## Technical Memorandum

**TO:** Ralph Dollhopf, United States Environmental Protection Agency

**FROM:** Sonny Rutkowski, Rex Johnson, Chris Lantinga Weston Solutions, Inc. (WESTON) START

**SUBJECT:** Enbridge Oil Spill Submerged Oil Containment Strategy: Recommendations for Submerged Oil Containment at Morrow Lake Delta, Ceresco Dam, and Mill Pond Impoundments

Figure 5  
Cable Stay Between Anchor Alternates

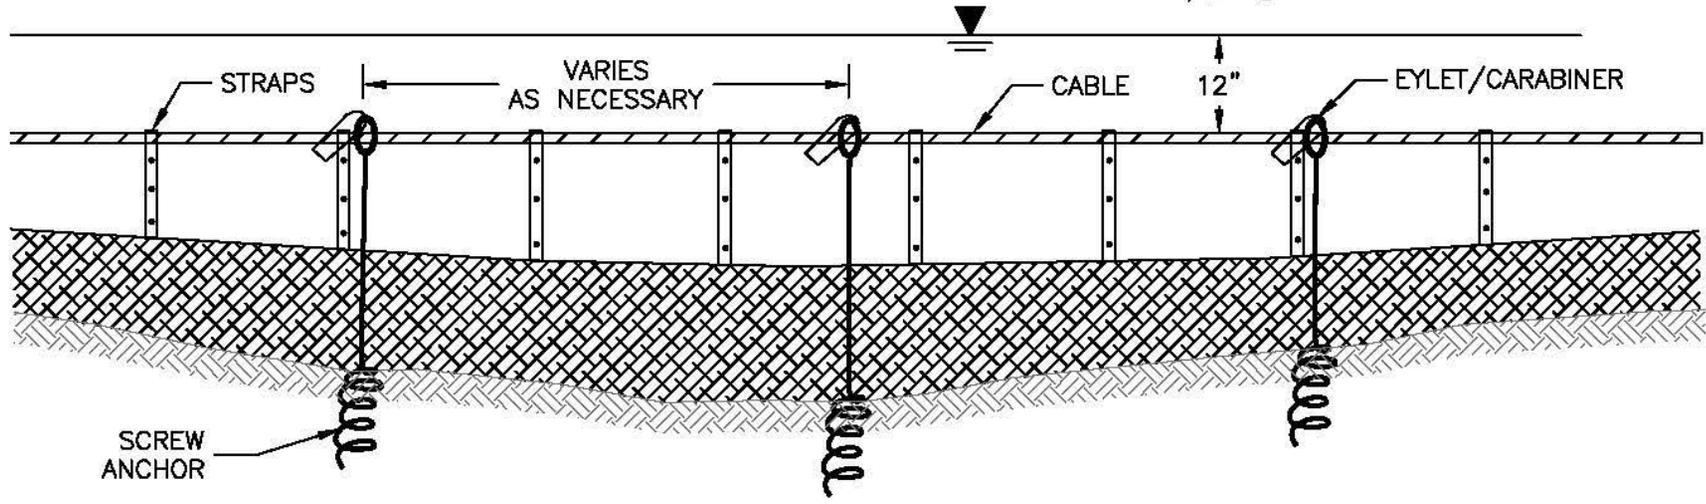
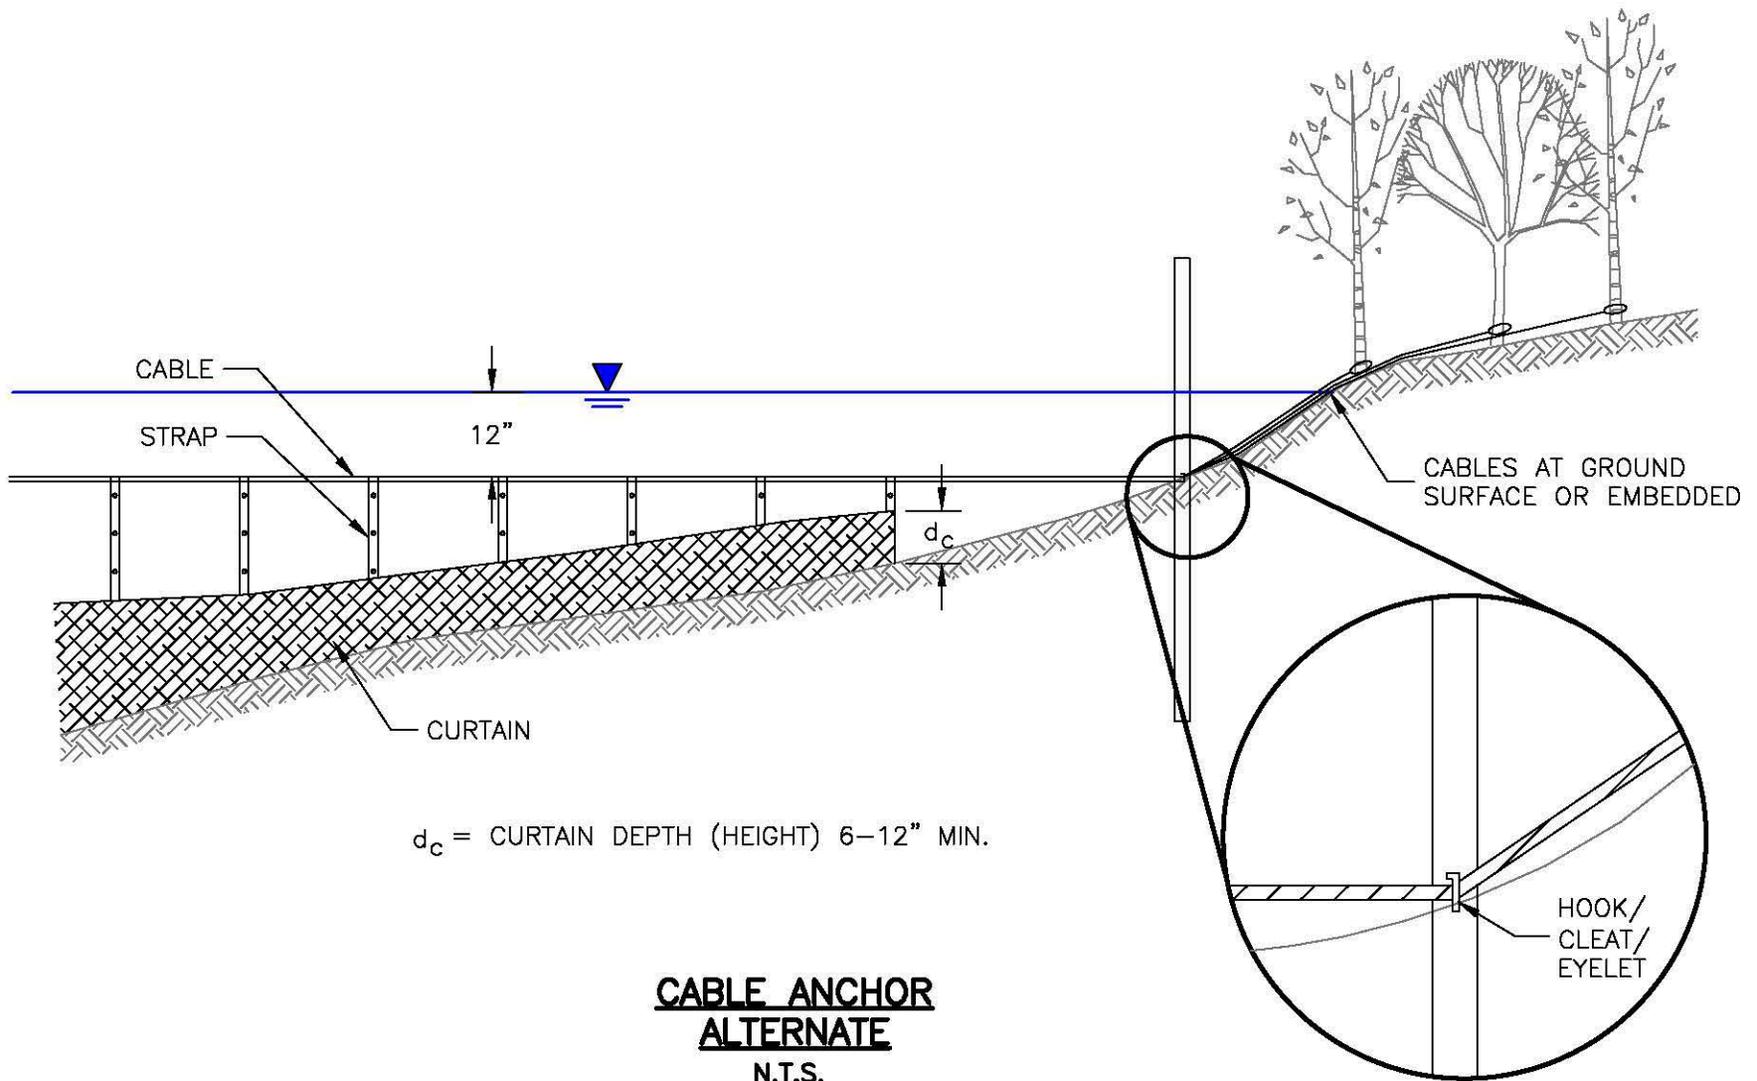
To allow adequate flow passage during freeze conditions, the straps should be adjusted so the bottom of the curtain remains in contact with the riverbed and the top of the curtain is the lesser value of 2' above the riverbed or half the elevation difference between the riverbed and the bottom of the ice zone (See Figure 5). Removal of the existing float at the top will be required prior to lowering the cable to the acceptable depth for ice clearance. In the current configuration, this float provides the necessary vertical stability force to prevent sagging and keep the cable and boom on the water surface. The new configuration must incorporate a similar cable stability component into the design. Based on rough estimates of the observed water displacement of the existing booms, the vertical force required countering the weight of the cable and boom against sagging below the surface is approximately 2-5 lbs per linear foot. Ball buoys could be affixed to the realigned cable at depth and even spacing. The size and spacing would be approximately 8-inch balls at 25-ft spacing; 10-inch balls at 50 foot spacing; or 12-inch balls at 100-ft spacing. See Figures 4 and 5.

Figure 6  
Cable Anchor Alternate

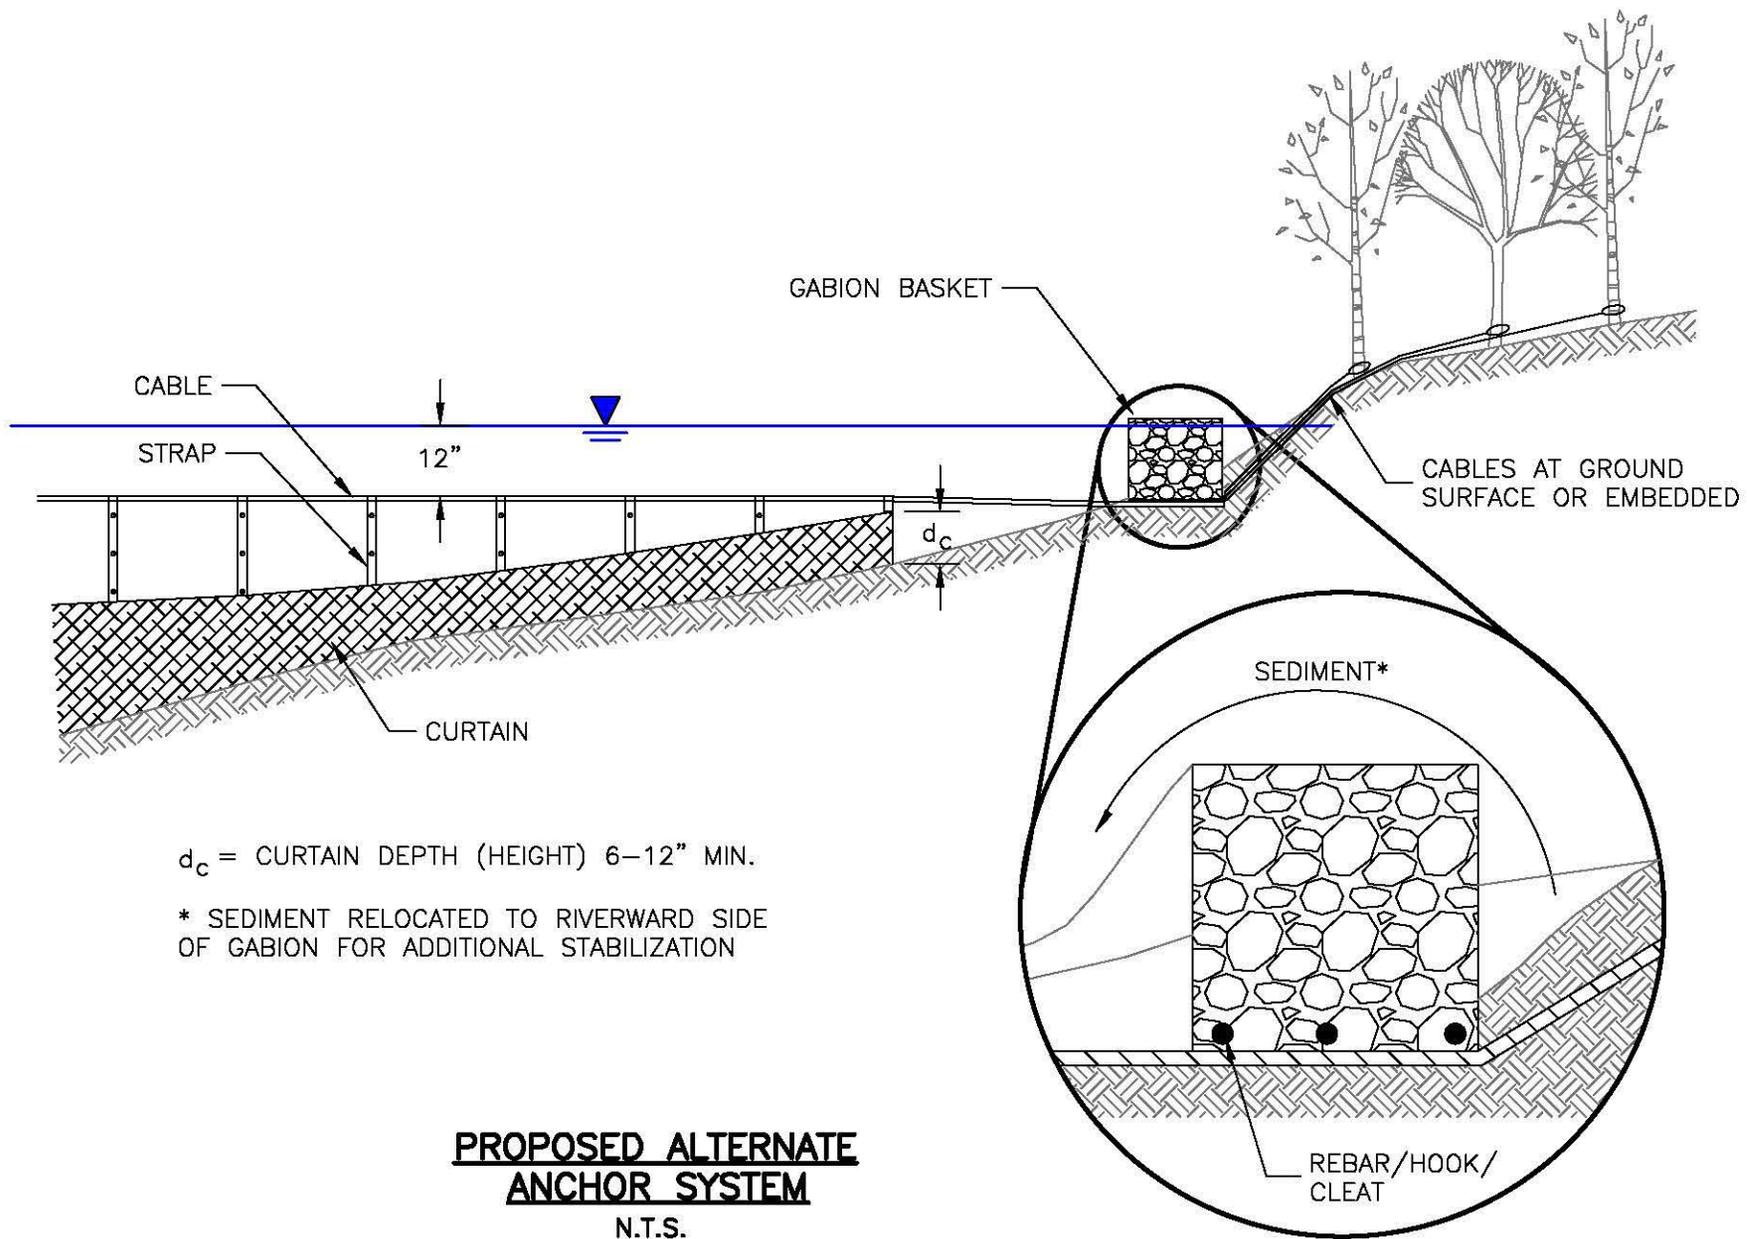
The shoreward ends of the cables should be affixed to the riverbed where water depths exceed 2 feet. The shoreward end of each curtain segment currently attaches to a tree (typical) or anchor post at an elevation within a few feet above the water surface. If these existing anchoring systems are used for the winter configuration, the sections of cable length nearest the shoreline should be lowered to the riverbed or imbedded so they are not exposed to ice floes. An additional anchor post or heavy weight with cable fasteners could be used to redirect and secure the cable against the riverbed at the 1-2 foot water depth nearest the shoreline. This would serve the dual purpose of aligning the cable at least 1 foot below water surface for ice clearance, and keep the shoreward end of the cable closer to the riverbed at the margins of the river where it will be better protected from ice forces. See Figures 6, 7, and 8 for possible anchoring reconfigurations.
